ArevaEPRDCPEm Resource

From: WILLIFORD Dennis (AREVA) [Dennis.Williford@areva.com]
Sent: Wednesday, August 10, 2011 4:36 PM
To: Tesfaye, Getachew
Cc: BENNETT Kathy (AREVA); DELANO Karen (AREVA); ROMINE Judy (AREVA); RYAN Tom (AREVA); NOXON David (AREVA)
Subject: Response to U.S. EPR Design Certification Application RAI No. 273, FSAR Ch 11, Supplement 16
Attachments: RAI 273 Supplement 16 Response US EPR DC.pdf

Appended to this file are affected pages of the U.S. EPR Final Safety Analysis Report in redline-strikeout format which support the response to RAI 273 Questions 11.05-2, 11.05-5, 11.05-7, 11.05- 8, 11.05-9, and 11.05-10.

Figure 9.3.2.1—Nuclear Sampling System
Sheet 2 of 9

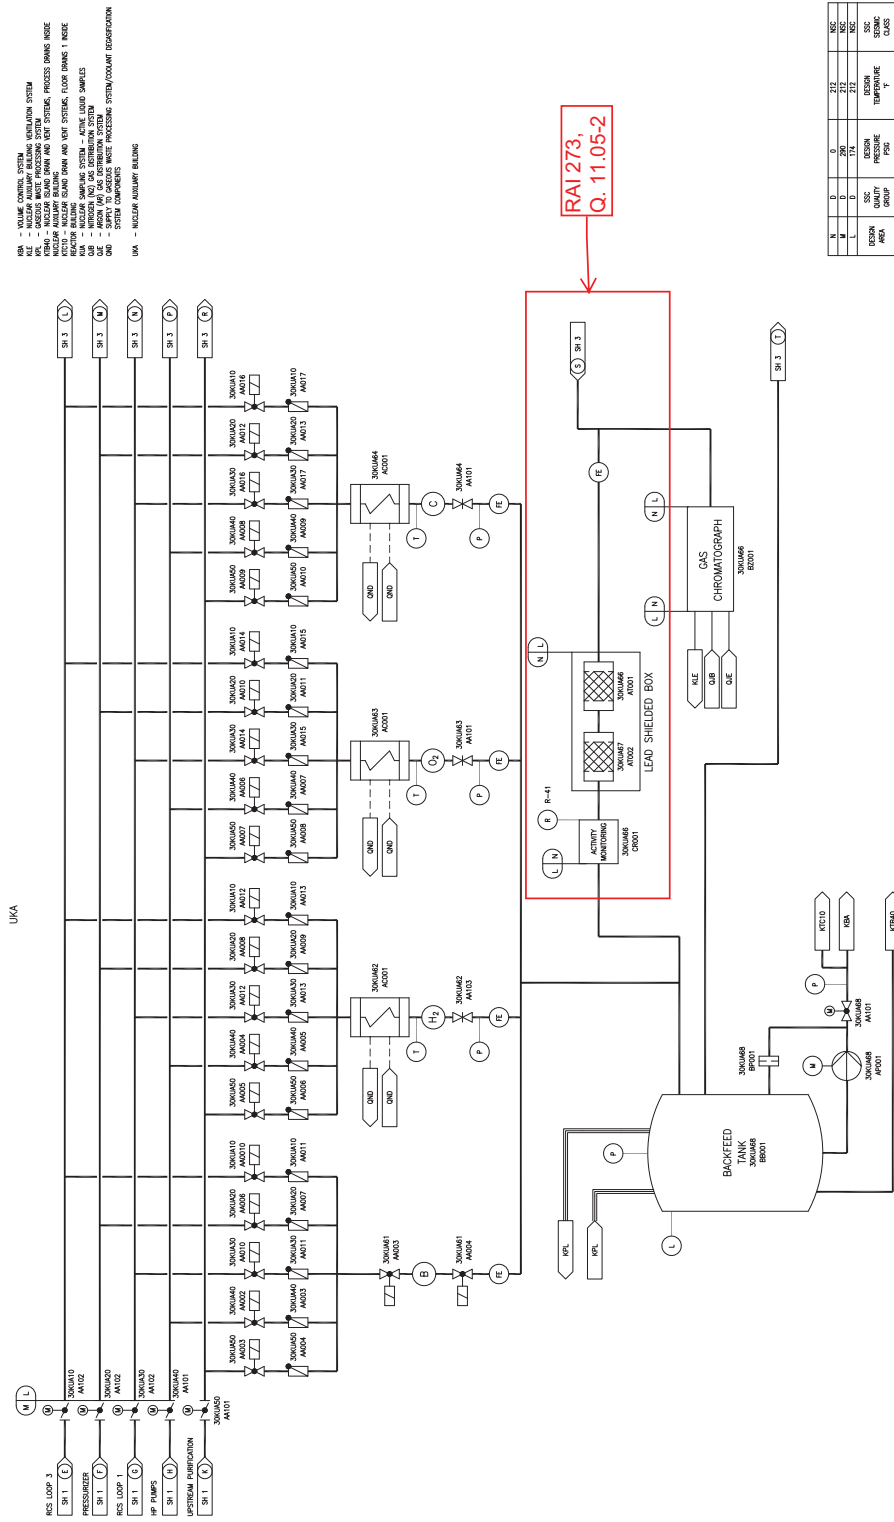
RAI 273,
Q. 11.05-2

Figure 9.4.1-1—Control Room Air Intake and CREF (Iodine Filtration) Train Subsystem

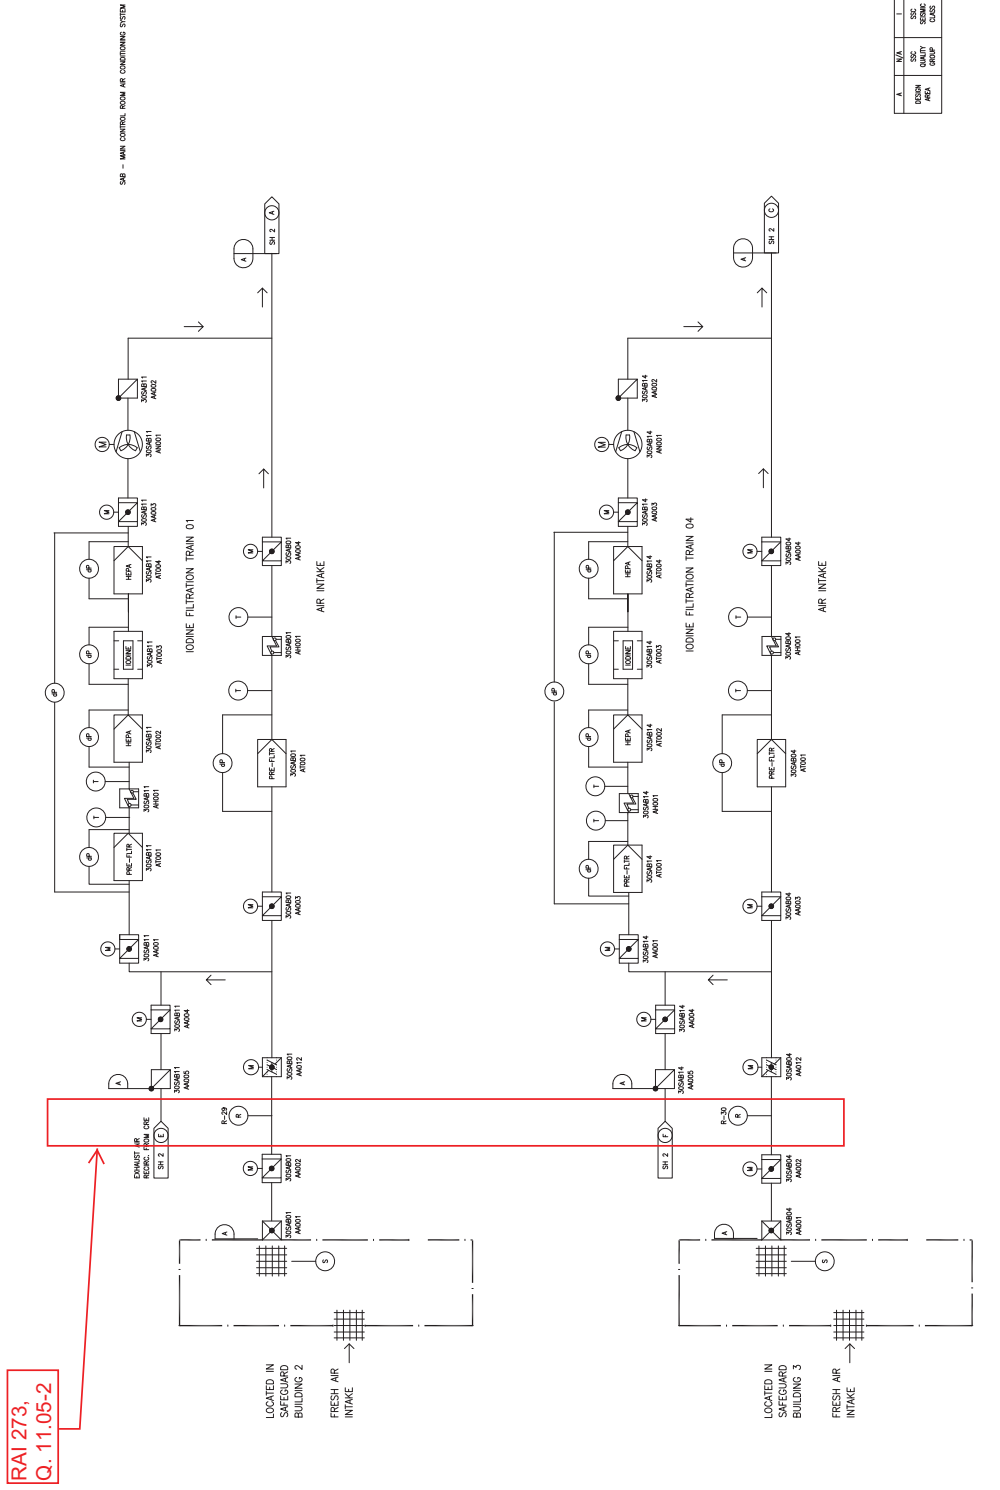
RAI 273,
Q. 11.5-02

Figure 9.4.3-5—Nuclear Auxiliary Building Laboratory Iodine Exhaust Filtration Train

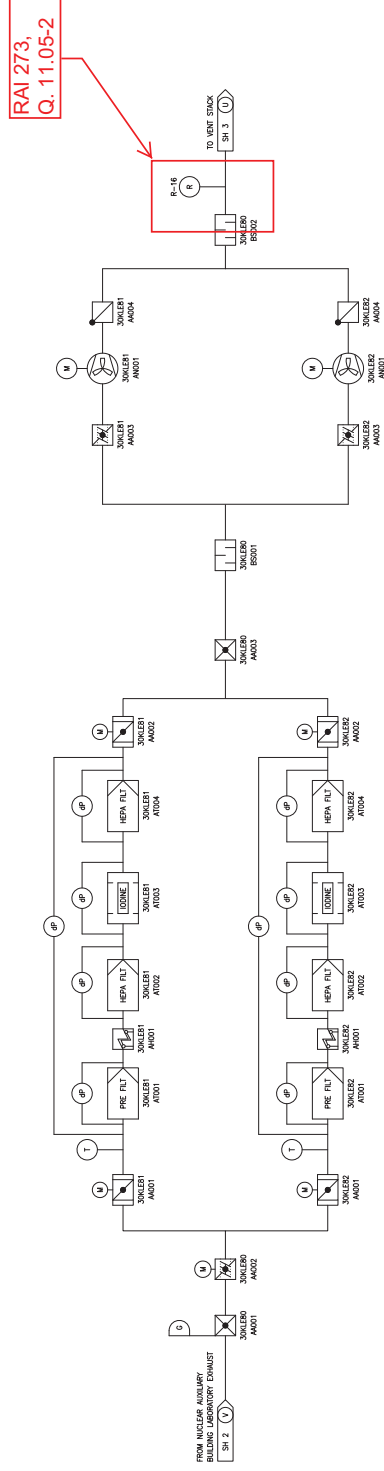
RAI 273,
Q. 11.05-2

Figure 9.4.5-2—Safeguard Building Controlled-Area Ventilation System Exhaust Air Subsystem

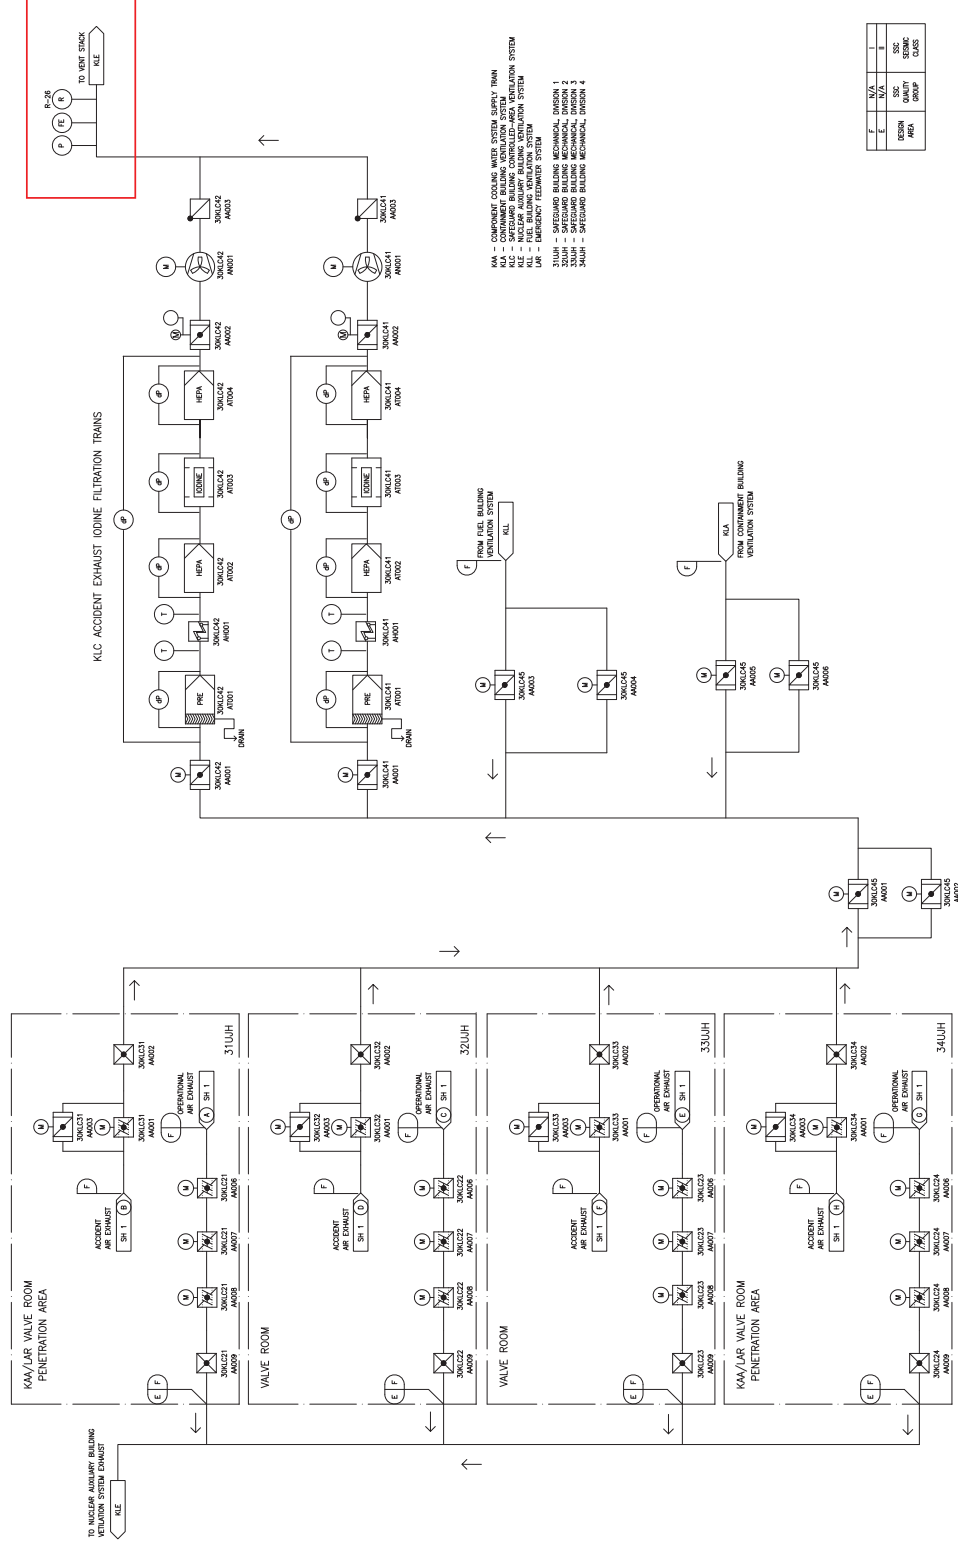
- b. Although FSAR Table 11.5-1 identifies the use of a multi-function process radiation monitor, its location could not be readily determined in FSAR Figure 9.4.5-2. Accordingly, Figure 9.4.5-2 should be reviewed to confirm whether its location is indicated and, if not, it should be added to the figure to ensure a complete representation of the system.

RAI 273,
Q. 11.05-2

Figure 9.4.8.2—Radioactive Waste Building Ventilation System Exhaust Air Station

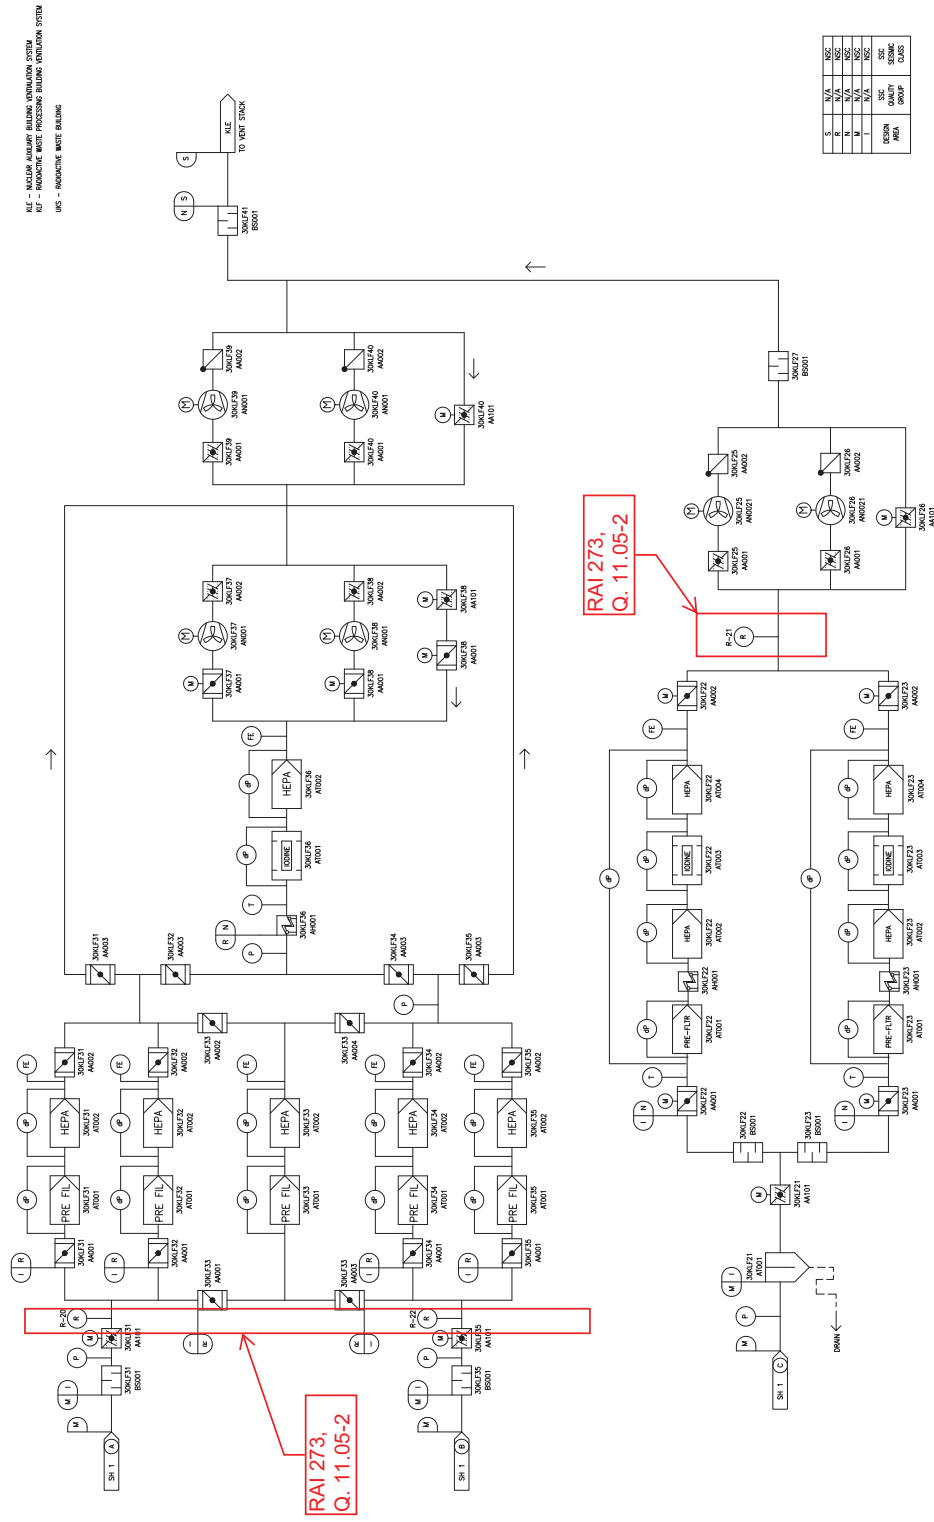
- b. Based on a review of FSAR Sections 11.5 and 9.4.8 figures and descriptions, it is not clear if a radiation detector is missing or one needs to be relocated in Figure 9.4.8-2 on the line coming from the RWBVS Processing Rooms (Line C from Sheet 1 to Sheet 2). In contrast, the corresponding lines from RWBVS Cells 1 and 2 show a radiation detector for Lines A and B from Sheet 1 to Sheet 2 before the filter trains. Accordingly, FSAR Sections 11.5 and 9.4.8 should be reviewed and revised to ensure a consistent presentation of design and operational features in understanding how RWBVS radiation monitors function and alert operators when effluent releases could exceed the effluent concentration limits of Appendix B to Part 20.

- c. In FSAR Table 11.5-1, the entry for the RWBVS radiation monitoring system indicates that there are two iodine radiation monitors and four aerosol radiation monitors. A review of FSAR Figures 11.5-1 and 9.4.8-2 indicates that the placements of these monitors is not clear given that there are three input flows to the RWBVS exhaust, one for Cell 1 and one for Cell 2 (Lines A and B from Sheet 1 to Sheet 2), and one for the RWBVS Processing Rooms (Line C from Sheet 1 to Sheet 2). There is no rationale provided for having one set of radiation monitors before each particulate/charcoal train for Cells 1 and 2 vent exhausts and none after it, and no explanations for the placement of the Processing Rooms monitor after the particulate/charcoal train with none before it. Accordingly, FSAR Sections 11.5 and 9.4.8 should be reviewed and revised to provide the technical rationale for the placement of radiation monitoring instrumentation in ensuring that effluent releases do not exceed the effluent concentration limits of Appendix B to Part 20.

U.S. EPR FSAR Tier 2, Section 9.4.8, Table 11.5-1, and Figure 9.4.8-2 will be revised as described in the response to this question provided in RAI 273, Supplement 4 and indicated on the enclosed markup.

Figure 9.4.14-2—Access Building Ventilation System – Supply and Exhaust Air Subsystem

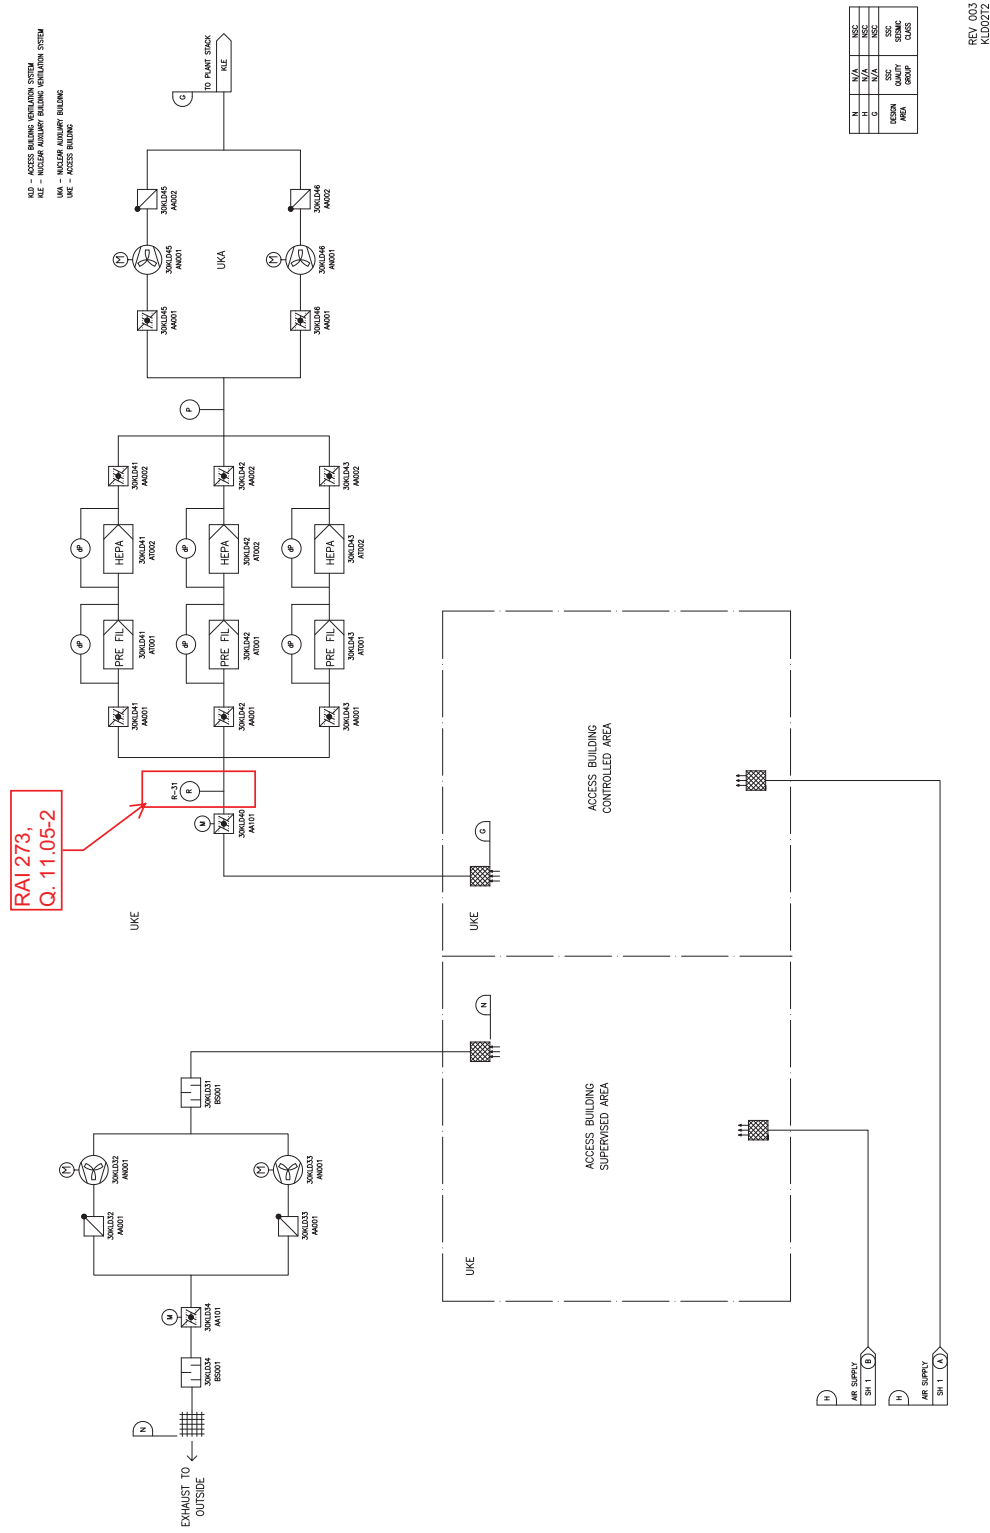
- a. FSAR Table 11.5-1 identifies only a sampling system for the ABVS, while FSAR Figure 9.4.14-2 identifies a radiation monitor instead before the filtration train. Accordingly, FSAR Sections 11.5 and 9.4.14 should be reviewed and revised to ensure a consistent description of radiation instrumentation and design features used in controlling airborne radioactivity releases via the plant vent.
- b. FSAR Section 9.4.14.6 provides information on instrumentation requirements for the ABVS. However, Section 9.4.14.6 does not refer to FSAR Section 11.5 and Table 11.5-1 for specific details on the associated radiation monitoring equipment for the ABVS. Accordingly, FSAR Sections 11.5 and 9.4.14 should be reviewed and revised to ensure a consistent use of internal references on radiation instrumentation design features in controlling airborne radioactivity releases via the plant vent.

U.S. EPR FSAR Tier 2, Figure 9.4.14-2 and Table 11.5-1 will be revised as described in the response to this question provided in RAI 273, Supplement 4 and indicated on the enclosed markup.

Figure 11.5-1—Radioactive Effluent Flow Paths With Process and Effluent Radiation Monitors

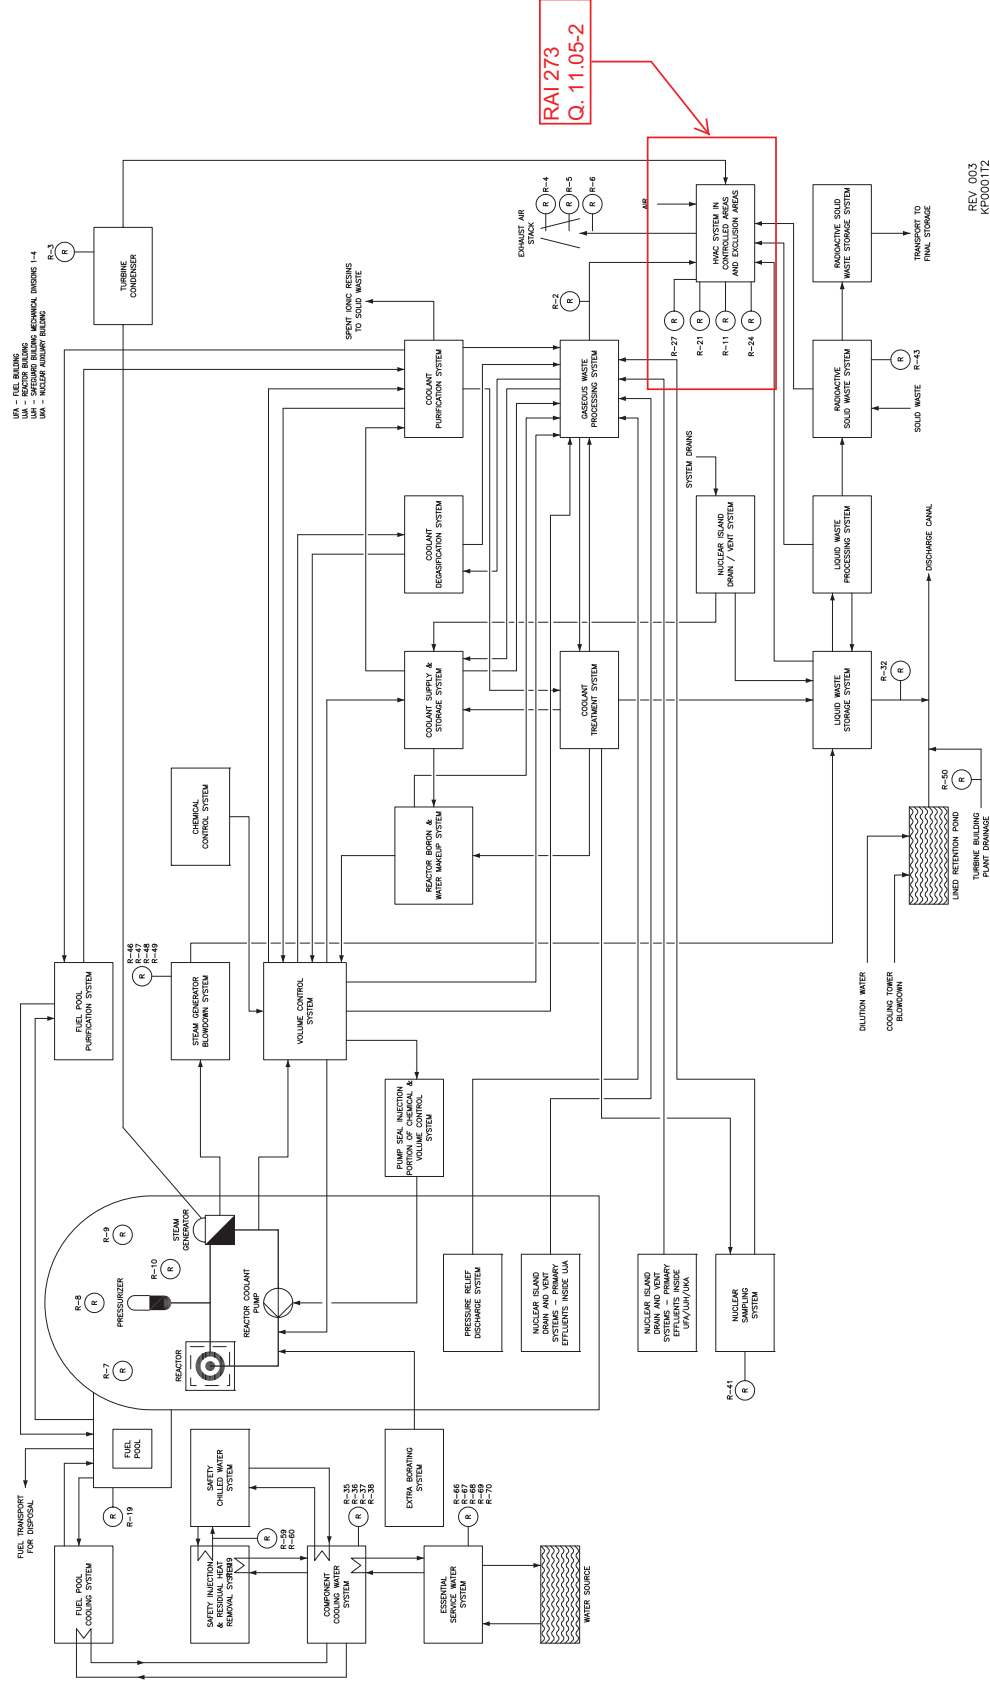
- 10) FSAR Figure 11.5-1 shows a radiation monitor on the Turbine Building Plant drainage line, but this monitor is not listed in FSAR Table 11.5-1.
